# UNITED STATES PATENT AND TRADEMARK OFFICE

APPLICATION NO.	FILING DATE	FIRST NAMED INVENTOR	ATTORNEY DOCKET NO.	CONFIRMATION NO.
10/633,557	08/05/2003	Kaoru Sato	43890-618	7144

## Office Action Summary

### **DETAILED ACTION**

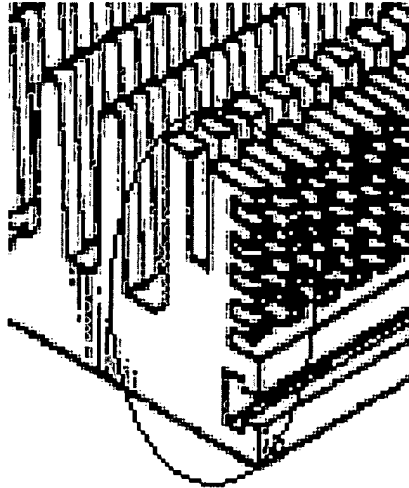
Claim 29 is rejected under 35 U.S.C. 102(b) as being anticipated by Jordan et al. As shown on the following page, Jordan et al (circled region) discloses a column having a perpendicular side face with respect to the heat receiving face, a plurality of fins parallel to the heat receiving face, and blower 11 mounted thereon.
